Access Compliance Report

Public Rights-of-Way

Intersection ID: 27798	Main Street: BRIARWICK_LN	Cross Street: BUFFTON_CT	Location: SW
ADA ID: 3DD88B9D16B4	Ramp Type: PerpDiag	Initial Pass/Fail: Fail	Overall Compliance: No
Codes/Mitigation Info/Possible Solution		Field Measurements/Component Compliance	
Severity Score: 12.5

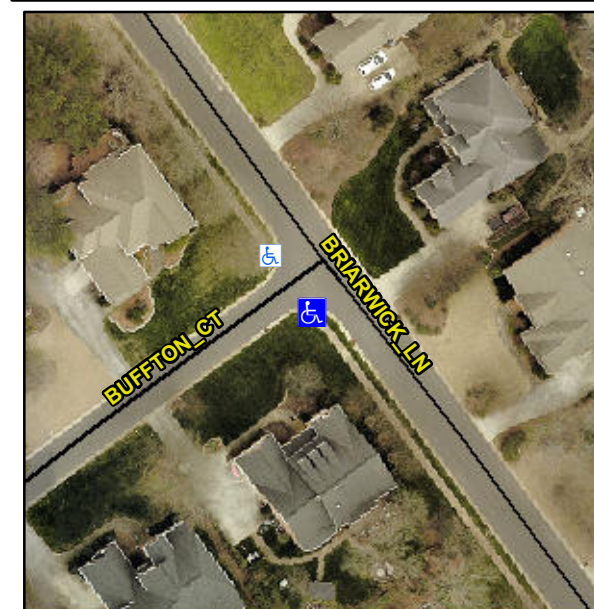
PROW/ADA:

R304.2.2

Compliance	Description	Data	Compliance	Description	Data
N/A	Ramp Length (in)	96.0	No	Ramp Slope (%)	8.6
Yes	Ramp Width (in)	48.0	Yes	Ramp XSlope (%)	1.3
N/A	Flare Type LT	N/A	N/A	Flare Type RT	N/A
N/A	Flare Slope LT (%)	N/A	N/A	Flare Slope RT (%)	N/A
N/A	Flare Traversable LT?	N/A	N/A	Flare Traversable RT?	N/A
N/A	Landing Length (in)	N/A	N/A	DWS Provided?	N/A
N/A	Landing Width (in)	N/A	N/A	DWS Contrast?	N/A
N/A	Landing Slope (%)	N/A	N/A	DWS Length (in)	N/A
N/A	Landing X Slope (%)	N/A	N/A	DWS Full Width?	N/A
N/A	Landing Curb? (Y/N)	N/A	N/A	DWS Offset (in)	N/A
N/A	Shared Landing?	N/A			
N/A	Gutter Ponding?	N/A	N/A	Gutter Slope (%)	N/A
N/A	Gutter Lip Ht (in)	N/A	N/A	Gutter X Slope (%)	N/A
N/A	Painted X Walk1?	No	N/A	Painted X Walk2?	No
	X Walk 1 Direction	To NE		X Walk 2 Direction	To NW
N/A	X Walk 1 Width (in)	N/A	N/A	X Walk 2 Width (in)	N/A
	X Walk 1 Slope (%)	2.0		X Walk 2 Slope (%)	1.1
	X Walk 1 X Slope (%)	1.3		X Walk 2 X Slope (%)	0.5

Remove & Replace Curb Ramp With Two New Directional Ramps or Equivalent.
